COUNCIL SUBMISSION

SSD 10459 – CENTRAL SYDNEY INDUSTRIAL ESTATE AND DOWNER SUSTAINABLE ROAD PRODUCTS COMPLEX

Figure 1: Theoretical visibility and assessed viewpoints

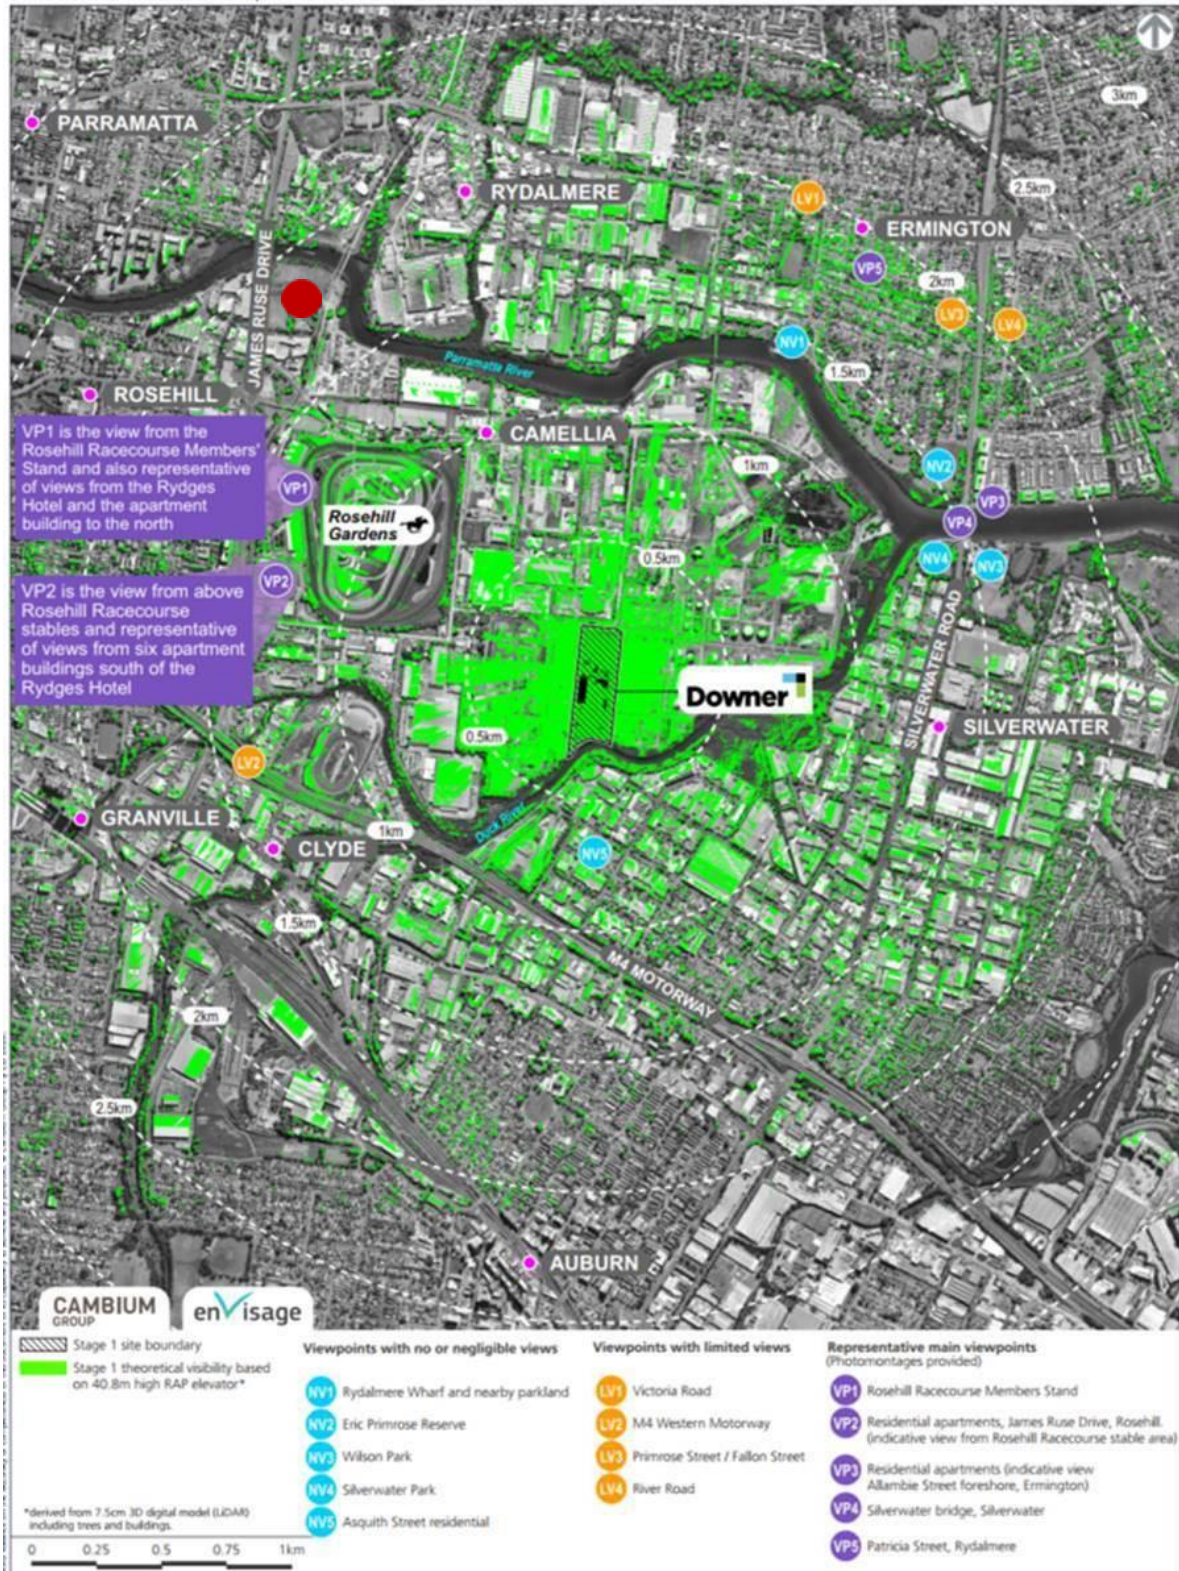
The EIS has assessed the potential visual impact from five public and private viewpoints including the following (refer to **Figure 1** below):

Land Use Planning Officers have reviewed the assessment and consider that the impact on the visual amenity of the off-site viewpoints is considered low to moderate. It is noted however the visual impact analysis, does not include visual impact assessment from the potential future Camellia Town Centre. It is also noted from our last meeting with the applicant, that more proximate views such as the view from along/across the river (Carnarvon Street) may be significant – if nothing else as a wayfinding and skyline/night-lighting features recreating the industrial aesthetic of the former refinery.

It is noted that the EIS has addressed the potential impacts regarding the visibility within Camellia by describing that any visual change associated with the staged subdivision and earthwork would result in a minimal visual impact without having completed any views analysis to demonstrate this. The Planning Proposal for 181 James Ruse Drive, Camellia (part of the future Camellia Town Centre) seeks to have residential buildings up to 40 storeys (126m) and is currently with DPIE for finalisation. Whilst this Planning proposal is still yet to be gazetted by DPIE, and is currently awaiting State Government decision on Camellia, it is requested that a visual impact assessment be carried out from 181 James Ruse Drive site as an viewpoint from the potential Camellia Town Centre (Please refer to the circle shown in red in **Figure 1** below) from the upper levels. This is consistent with Council's previous advice.
